## BEAUMONT SUMMIT STATION PROJECT

### FINAL ENVIRONMENTAL IMPACT REPORT

Plot Plan - PP2021-0388  
General Plan Amendment - PLAN2021-0656  
Tentative Parcel Map - PM2021-0009  
Specific Plan Adoption - SP2021-0005

July 2022

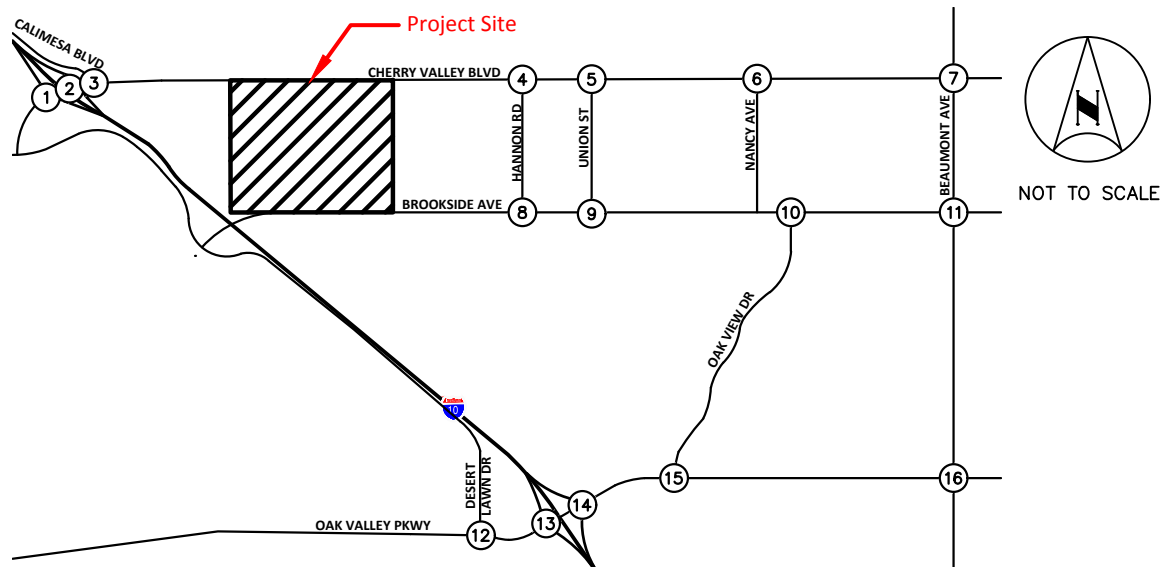
6. Figure 4 – Existing Traffic Volumes, page 11: Intersection 2, I-10 westbound ramps/Cherry Valley Boulevard, is missing the northbound (off-ramp) approach peak hour traffic volumes. Upon further investigation of the LOS worksheets in Appendix C, the northbound approach volumes were also not included in the LOS analysis. Therefore, delay and LOS values at this intersection are in error and the analyses should be corrected.

**L3-13** Figure 4 and the Existing Conditions analysis has been updated accordingly. Subsequent scenarios (Opening Year and Horizon Year) reflected the correct northbound approach peak hour volumes in the analysis at Intersection #2 (I-10 WB Ramps at Cherry Valley Boulevard).

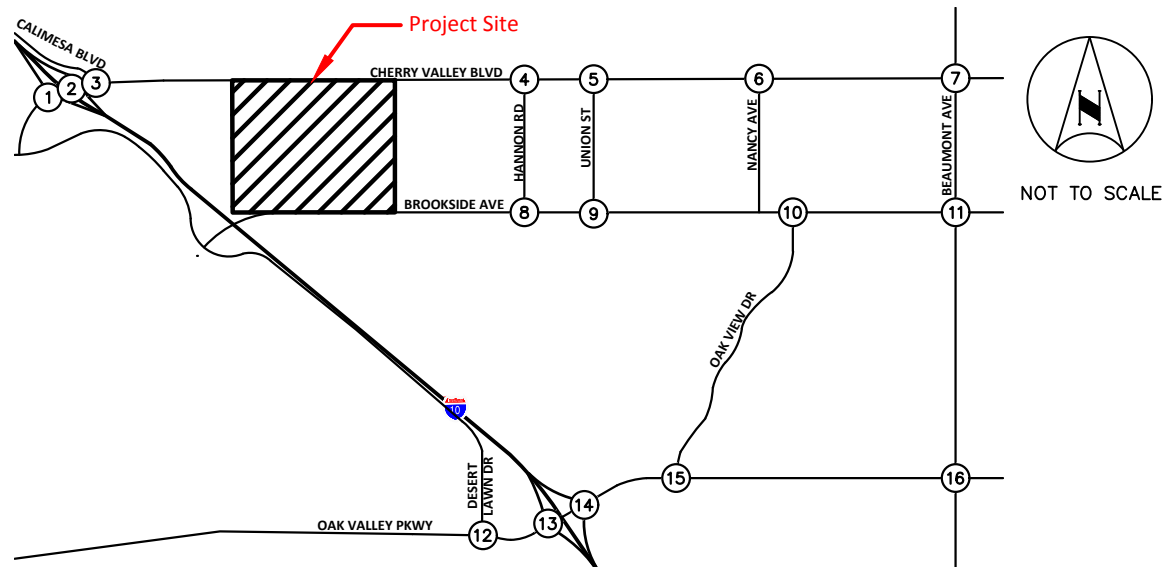
8. Figure 15 – Horizon Year 2040 Traffic Volumes, page 42: Review of the AM peak hour traffic volumes in the eastbound direction at the I-10/Cherry Valley Boulevard interchange shows an increase of 100 vehicles per hour (vph) on the eastbound approach to the westbound ramp intersection. While it is anticipated that traffic volumes at the closely spaced ramp intersection may be slightly different due to rounding and the post-processing of modeled traffic volumes, a discrepancy of 100 vehicles per hour could significantly change the intersections' delay and LOS values. Therefore, the traffic volumes and LOS results at this interchange are in error and should be re-analyzed.
